APPENDIX D – MODIFICATION LIST

1) Inverter shield cover

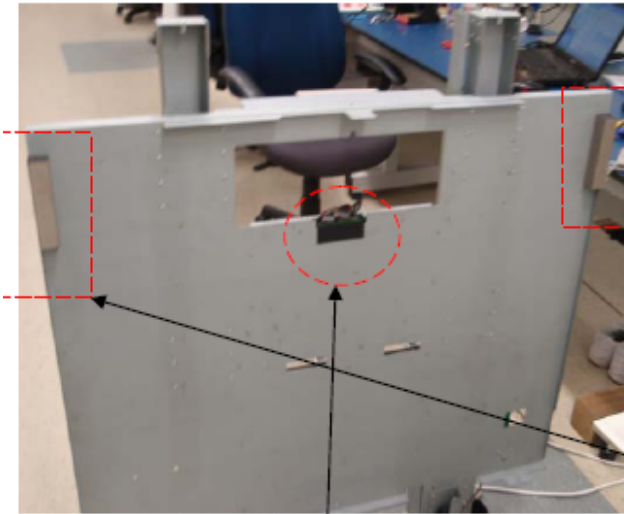
EMI form gasket
20(W)*10(H)*100(L)mm
(2 positions)

2) Main chassis frame

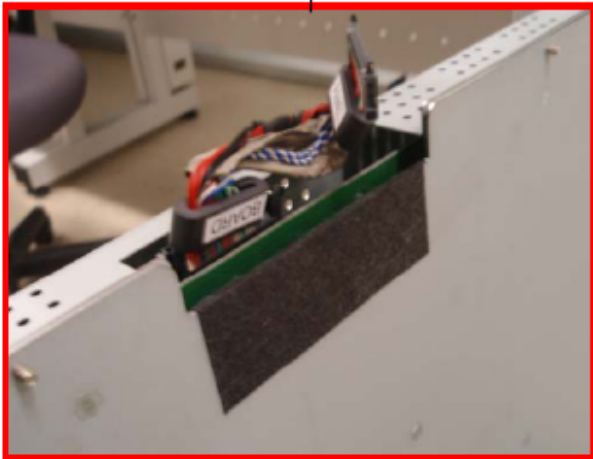
EMI form gasket
27(W)*30(H)*135(L)mm
(2 positions)

Felt tape 85*85mm
(2 positions)
: In order to prevent contact this point and LVDS cable

3) AC power input

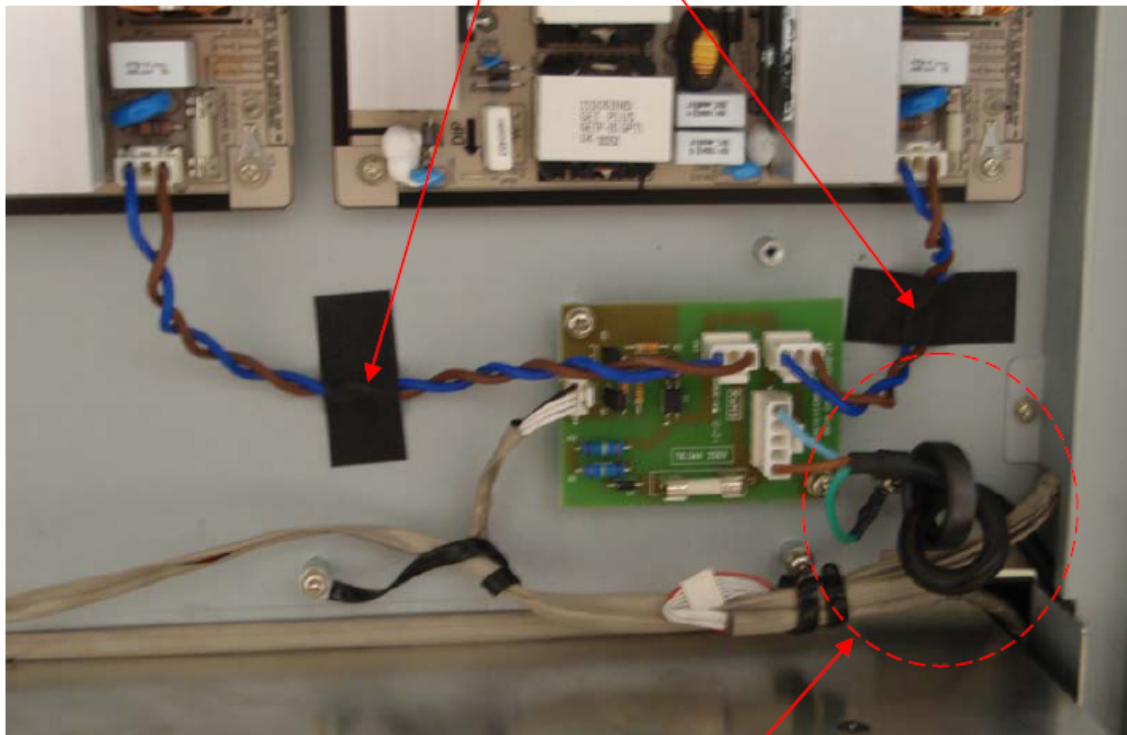
Divide 2 AC input cable like this, don't bind with clamp.

Add EMI ferrite core on the AC Input.

And we need to consider how to fasten this core without rattling sound.
